WATTS-SLAUGHTER SUBDIVISION, **RESUBDIVISION OF LOT 2**

APPLICATION NUMBER 6 DATE July 15, 2021

REQUEST Subdivision

DETAIL SITE PLAN

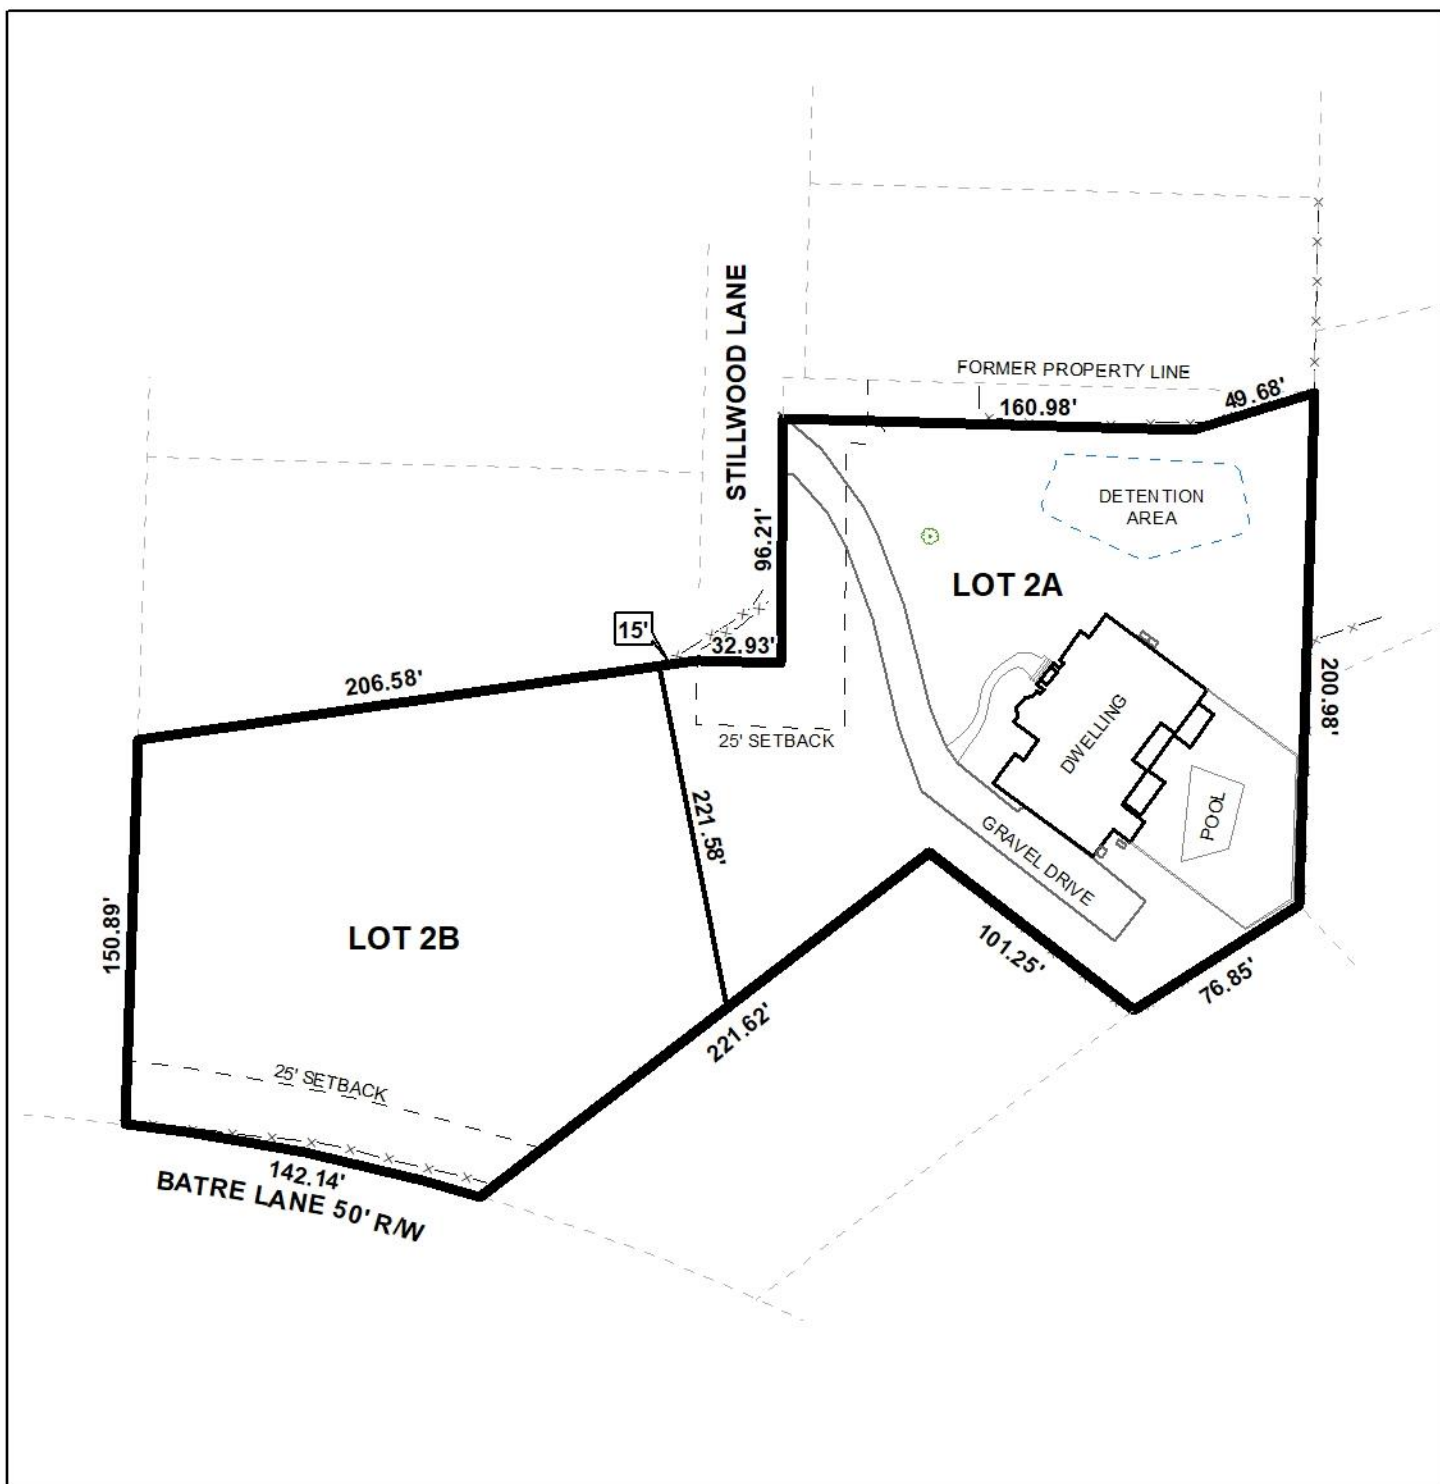
The proposed Lot 2A fronts Stillwood Lane North while Lot 2B has frontage on Batre Lane. Both are minor streets without curb and gutter requiring a minimum 60-foot right-of-way (ROW) width. As such, the preliminary plat illustrates a non-compliant ROW for both Stillwood Lane and Batre Lane listing them as "Variable" and "50 feet", respectively. However, it should be noted that the plat of record in accordance with the 2002 subdivision approval of the subject site likewise illustrates the ROW for this portion of Stillwood Lane as "Variable". Likewise, a nearby subdivision approved by the Commission at its September 17, 2009 meeting and subsequently recorded in Probate Court, labels the ROW for Batre Lane as 50 feet. Additionally, the City currently does not have any plans to expand or widen either street. As such, and with a waiver of Section V.B.14 of the Subdivision Regulations, the ROW widths as illustrated would be compliant and should be retained on the Final Plat.

In regard to the irregular shape of the proposed lot, it should be noted that Section V.D.1. of the Subdivision Regulations states that, "...the shape and orientation of lots...shall be compatible and appropriate to the location of the subdivision and the type of development and use contemplated. [Irregularly shaped] lots shall generally not be allowed, but may be permitted only in those locations where varied and irregularly-shaped lot designs are common and the informality of design is consistent with other lots in the vicinity...". While no justification was provided pertaining to use or contemplated development there do appear to be other irregularly-shaped lots in the area such that the proposed lot shapes could be considered consistent. If approved, a waiver from Section V.D.1. of the Subdivision Regulations would be necessary.

The preliminary plat illustrates the proposed lot size as compliant provided in both square feet and acres and should be retained on the Final Plat. A compliant 25' minimum building setback is illustrated along both frontages and should be retained on the Final Plat as well, if approved.

No easements are indicated on the preliminary plat. If any easements are recorded on the site they should be indicated and labeled on the Final Plat, and a note should be placed on the Final Plat stating that no structure may be placed or constructed within any easement without permission of the easement holder.

Based on the preceding, with waivers of Sections V.B.14. and V.D.1. of the Subdivision Regulations, this application is recommended for Tentative Approval subject to the following conditions:

- 1) Retention of the lot size in both square feet and acres, or the furnishing of a table on the Final Plat providing the same information;
- 2) Retention of the 25' minimum building setback along both frontages on the Final Plat;

- 3) Placement of a note on the Final Plat stating that no structure may be constructed or placed within any easement without the permission of the easement holder, if applicable;
